Village of Cassopolis

CWSRF Interceptor Force Main Replacement

ADDENDUM 1

June 12, 2026

Sheet G-0.3 – Overall Plan and Notes

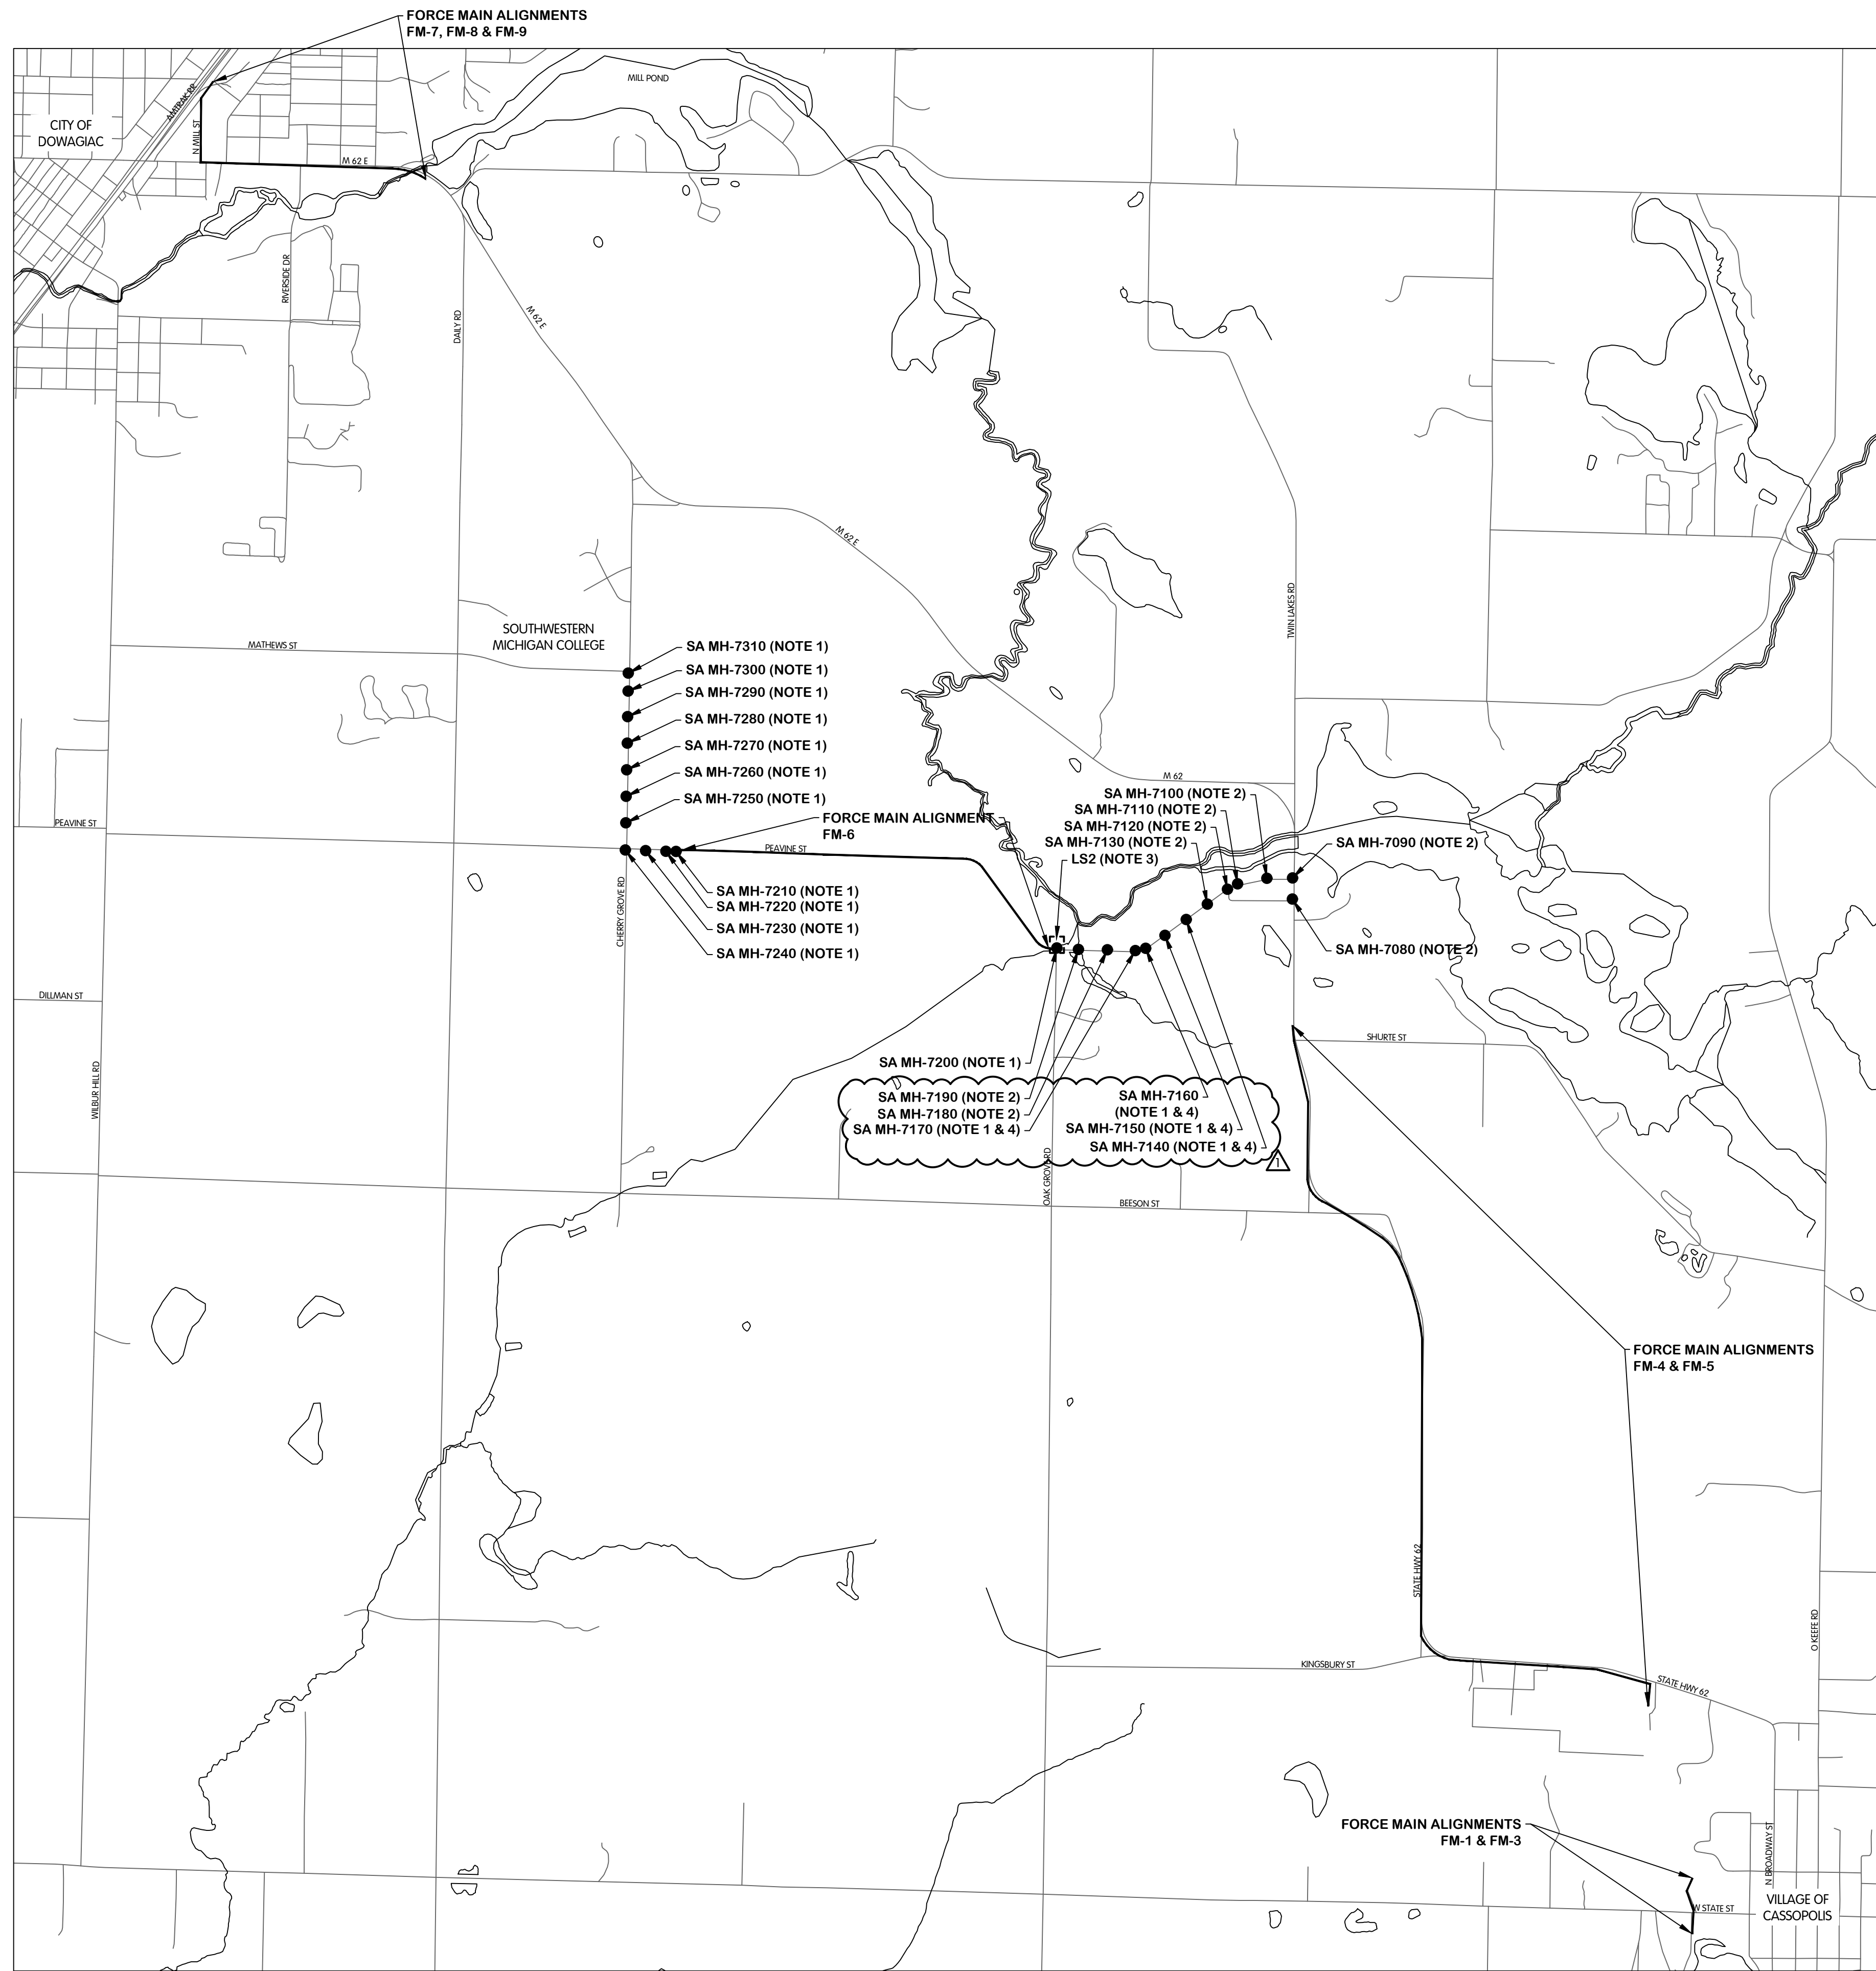
A fourth note has been added to this sheet as well as a change in the referenced note for SA MH-7170, SA MH-7160, SA MH-7150, and SA MH-7140. Replace the sheet with the provided Sheet G-0.3 included with Addendum 1.

- NOTES:
1. EXISTING MANHOLE STRUCTURES TO BE LINED.
 2. EXISTING MANHOLE STRUCTURES TO BE REMOVED, REPLACED AND LINED.
 3. SEE SHEET FM-0.2 FOR LIFT STATION 2 IMPROVEMENTS
 4. AFTER SURFACE PREPARATION HAS BEEN COMPLETED, ENGINEER SHALL INSPECT AND PROVIDE WRITTEN APPROVAL TO PROCEED WITH LINING FOR SA MH-7140, SA MH-7150, SA MH-7160, AND SA MH-7170.
